HISTORIC AND DESIGN REVIEW COMMISSION

February 07, 2018

HDRC CASE NO: 2018-034
ADDRESS: 121 BUFORD
LEGAL DESCRIPTION: NCB 1369 BLK 6 LOT S 81.3 FT OF 5
ZONING: R-4, H
CITY COUNCIL DIST.: 2
DISTRICT: Dignowity Hill Historic District
APPLICANT: Ryan McWhirter/LUSH Greenscape Design
OWNER: Chris H. Williams Laura Lopez
TYPE OF WORK: Front yard site elements
APPLICATION RECEIVED: January 17, 2018
60-DAY REVIEW: March 16, 2018
REQUEST:

entry elevation
scale: 1/4" = 1'-0"

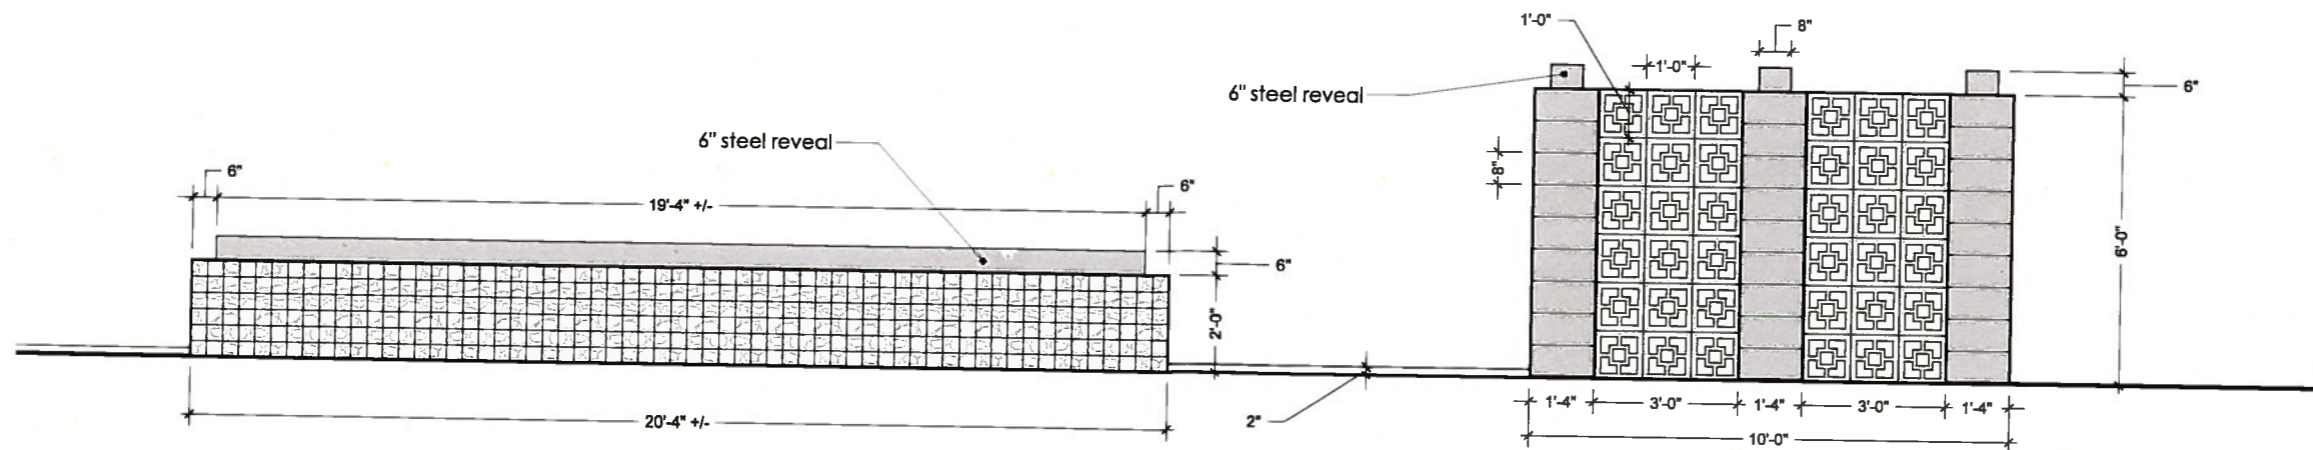
- i. **GABION WALL/ROCK PLANTER**– The applicant has installed a gabion wall prior to approval. The gabion wall features a steel cage filled with river rock (20’4” long, 36” deep, 24” tall) and is topped with a steel planter (19’4” long, 24” deep, 6” tall). The planter is proposed to feature black bamboo which will add up to 6 feet in height per the illustrations. Per the Guidelines for Site Elements 2.B.i, new walls should appear similar to those used historic within the district in terms of their scale, transparency, and character and that the design should respond to the design and materials of the house or main structure. Staff finds that there is absolutely no historic precedent on Buford Alley and its immediate neighboring blocks, nor the Dignowity Hill Historic District, nor the minimal traditional architecture style that calls for the installation of a gabion wall nor bamboo plantings that would screen a majority of the front façade.

- j. **MASONRY WALL/SOLAR SCREEN** – The applicant has installed a solar screen prior to approval. The solar screen (10’ wide, 6’ tall) features two perforated masonry panels between three CMU columns topped with 6” steel planters. The planters are proposed to feature giant hesperaloe which will add up to 2 feet per the illustrations. Per the Guidelines for Site Elements 2.B.i, new walls should appear similar to those used historically within the district in terms of their scale, transparency, and character and that the design should respond to the design and materials of the house or main structure, (2.B.iii) new walls are limited to four feet in height in the front yard, and (3.B.iv) concrete masonry units and concrete blocks are expressly prohibited construction materials for new fences and walls. Staff finds that there is no historic precedent on Buford Alley, within the Dignowity Hill Historic District or associated with the structure’s architecture style to support this installation.

8. Staff does not recommend the installation of a gabion wall that features bamboo plantings. Staff recommends the gabion wall be removed. The applicant may submit to staff a front yard fence design that is consistent with the Guidelines.

9. Staff does not recommend the installation of a solar screen as proposed. Staff recommends the solar screen be removed. The applicant may resubmit to staff a front yard fence design that is consistent with the Guidelines.

buford alley
entry garden plan

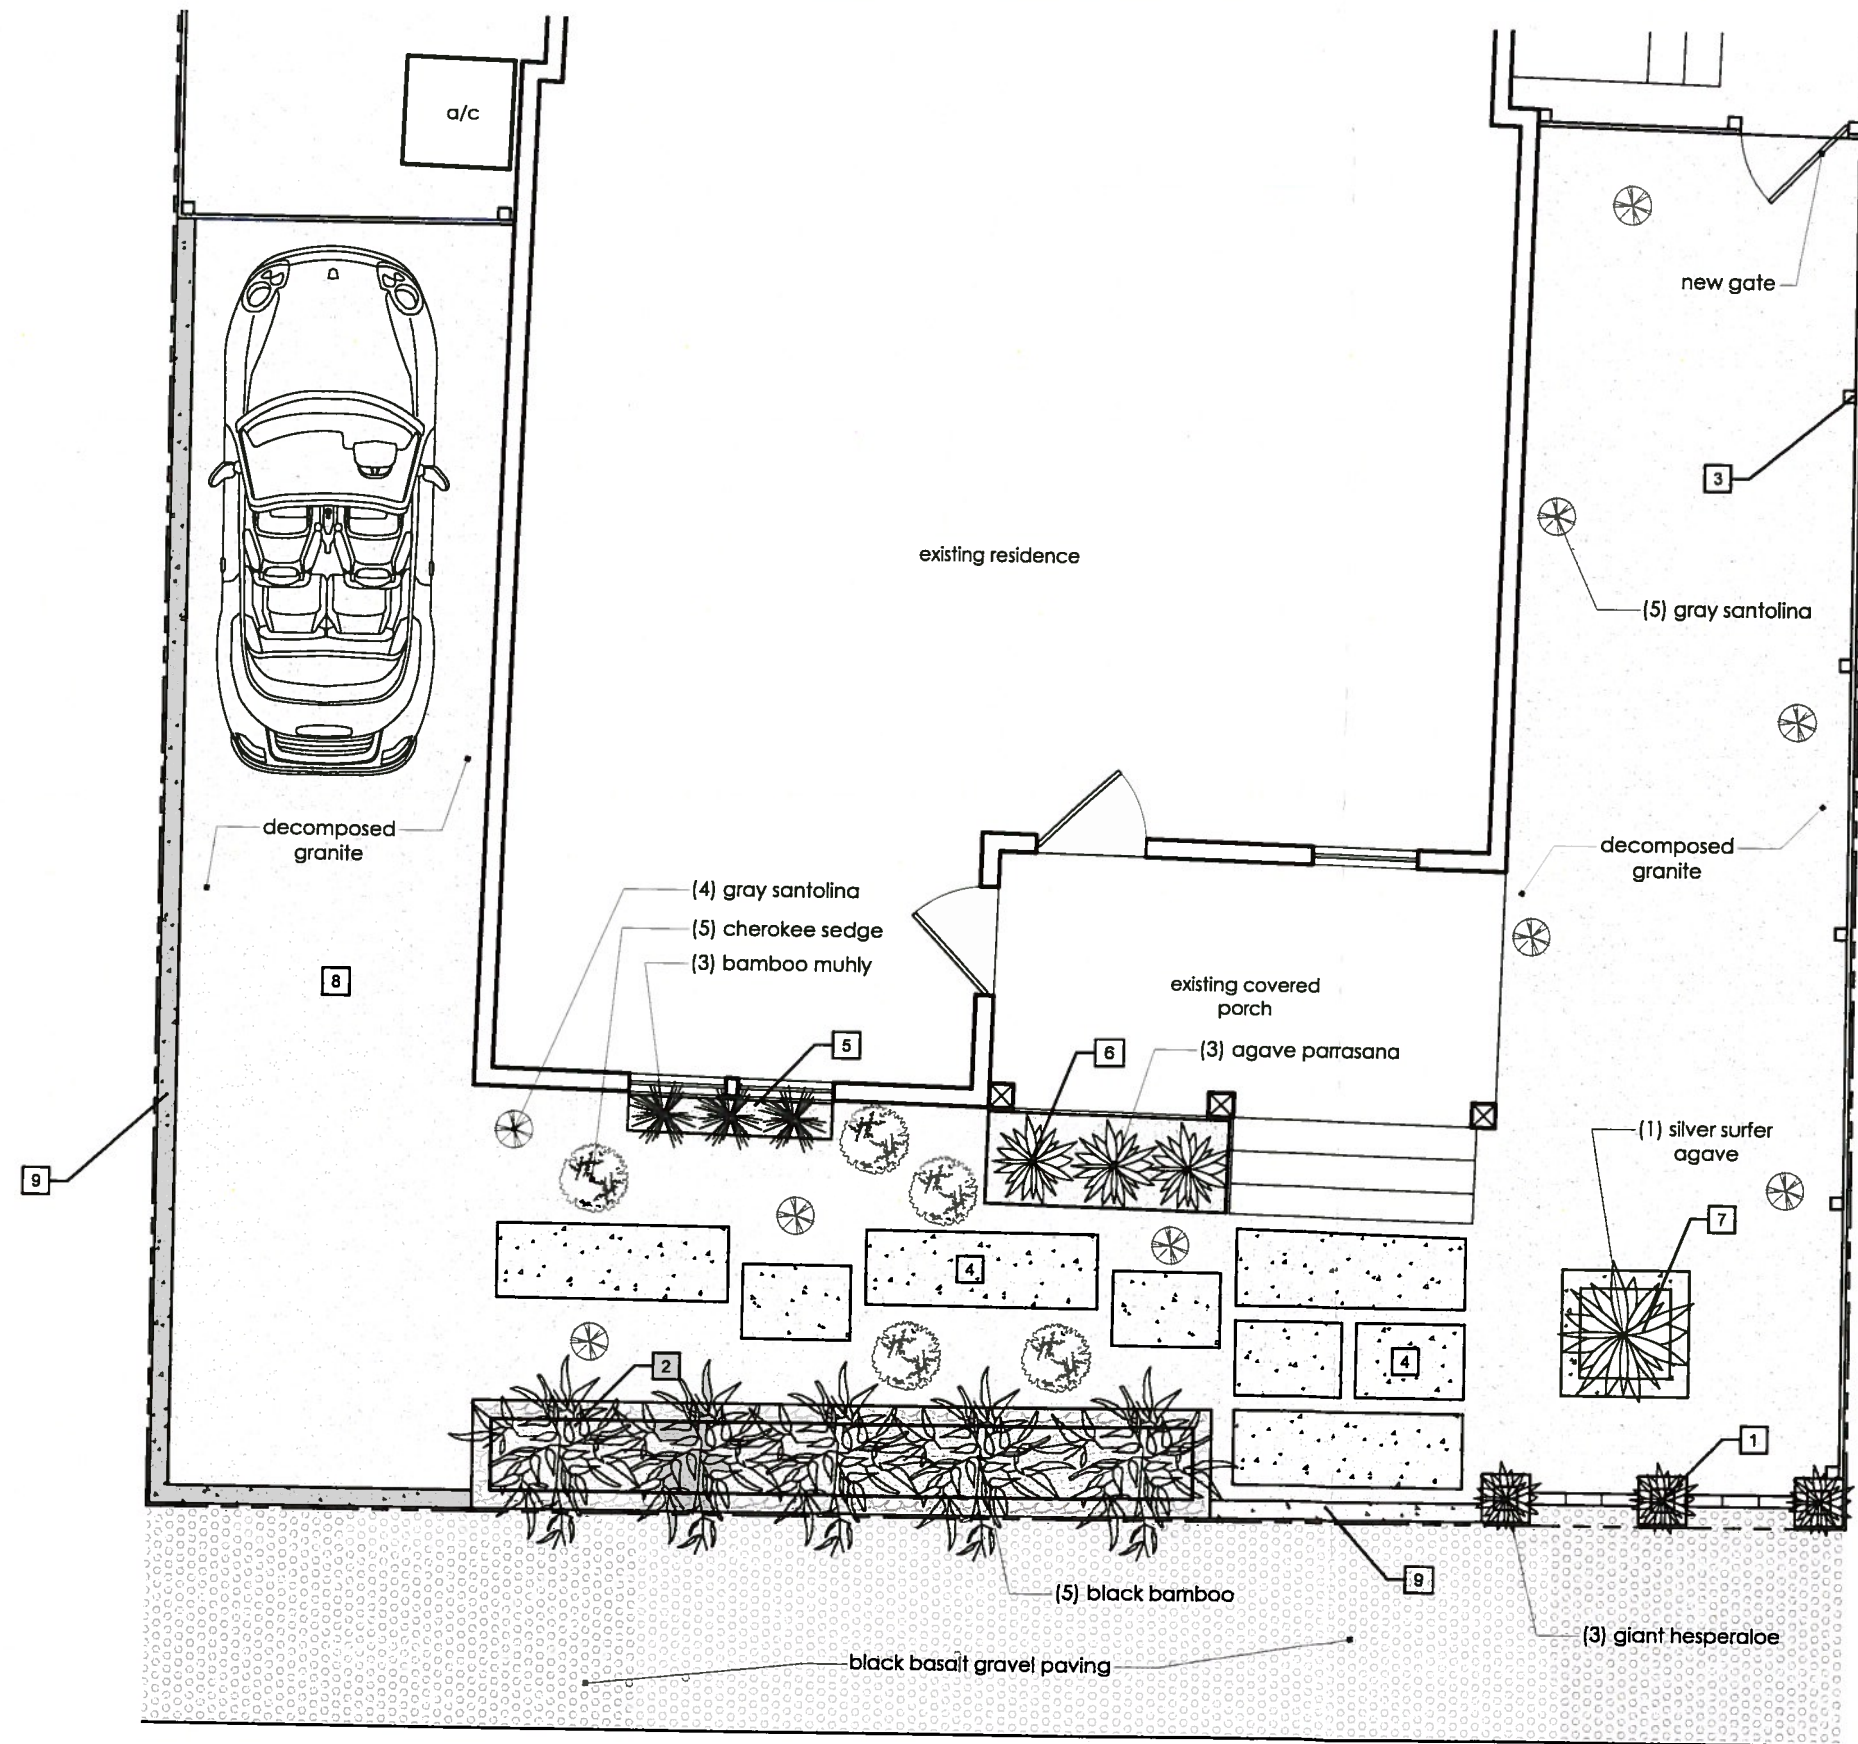
- b. FENCE – The applicant received administrative approval to install a privacy fence, featuring metal posts, and horizontal cedar planks to feature six feet in height in the rear and four feet in height past the rear plane of the front porch. The applicant has proposed a height beyond rear plane of the front porch of six feet in height to the public right of way. The applicant has failed to adhere to the administratively approved fence plan and has previously constructed a six foot tall fence in the front yard. Staff finds this request is inconsistent with Guidelines for Site Elements 2.B.iii., 2.C.i and ii.

- c. PARKING – The applicant has removed the sidewalk and portions of natural lawn and installed black basalt gravel to create a parking area in the front yard. Per the Guidelines for Site Elements 5.B and 5.C. every effort should be made to match existing sidewalk color and material when the original sidewalk is deteriorated beyond repair; new driveways should feature a similar configuration in materials, width, and design to that historic found on the site; applicants should avoid new curb cuts where not historically found and applicants should replace curbing in-kind when deteriorated beyond repair. Staff finds this request is not consistent with the aforementioned Guidelines. Staff also finds that the installation is a negative impact to Buford Alley by interrupting the public right-of-way sidewalk in lieu of private parking.

- d. XERISCAPE – The applicant has removed the natural lawn in the front and side yards and has begun the installation of decomposed granite and plantings. Per the Guidelines for Site Elements 3.A.ii and iii, historic lawns should never be reduced by more than 50%; and applicants should select native and/or xeric plants that thrive in local conditions and reduce water usage. Staff finds that the applicant has reduced the natural lawn far beyond 50% and that the proposed amount of plantings and ground cover is not yet sufficient to justify the xeriscaping requesting.

- e. CONCRETE PAVERS – The applicant has installed concrete pavers in the front yard prior to approval. Per the Guidelines for Site Elements 3.B.i, large pavers, asphalt, and impervious surfaces should not be introduced where they are not historically found. Staff finds that the request is inconsistent with the Guidelines and that the simple concrete walkway to the front porch should be restored after the removal of concrete pavers.

- f. STEEL PLANTER (BELOW WINDOW) – The applicant has installed a steel planter (68” long, 12” deep, 26” tall) prior to approval. The planter is located below the front façade window. Staff finds that the proposed massing and material of the planter is inconsistent with Guidelines for Site Elements 1.A.iii. The height of this planter should feature wood construction instead of steel and be reduced to match the height of the planter requested in finding g.

- g. STEEL PLANTER (BY PORCH)- The applicant has installed a steel planter (80” long, 32” deep, 16” tall) prior to approval. The planter is located adjacent to the front porch and steps. Staff finds that the proposed material of the planter is inconsistent with Guidelines 1.A.iii. The planter should feature wood construction instead of steel.

- h. CONCRETE PLANTER – The applicant has proposed to install a low-ground concrete planter with a steel skirt (30” long, 30” deep, 6” tall). The applicant has not begun this installation as of February 2, 2018. Staff finds that

the proposed material of the planter is consistent with Guideline 1.A.iii. The planter should feature wood construction instead of concrete and steel

1. Staff does not recommend approval of the proposed to amend the previously issued administrative Certificate of Appropriateness to allow 6-foot tall fencing beyond the rear plane of front porch. The approved design should be adhered to.

2. Staff does not recommend approval the removal of sidewalk and natural lawn for the installation of black basalt gravel parking. The gravel should be removed and the concrete sidewalk should be restored.

3. Staff does not recommend approval of the wholesale removal of natural lawn for the installation of decomposed granite and plantings as proposed. Staff recommends that portions of natural lawn should be reintroduced to the site or that additional low-ground plantings be installed, if the HDRC conceptually approves of the xeriscaping.

4. Staff does not recommend approval of the concrete pavers. Staff recommends their immediate removal followed by the reinstallation of a simple walkway from the sidewalk to the porch as historically found on the site.

5. Staff does not recommend the installation of the steel planter beneath the window as proposed. Staff recommends the applicant resubmit a planter design that features wood construction and a reduced height.

6. Staff does not recommend the installation of a steel planter adjacent to the porch and steps as proposed. Staff recommends the applicant resubmit a planter design that features wood construction.

7. Staff does not recommend the installation of the low-ground concrete planter with a steel skirt. Staff recommends the applicant resubmit a planter design that features wood construction.
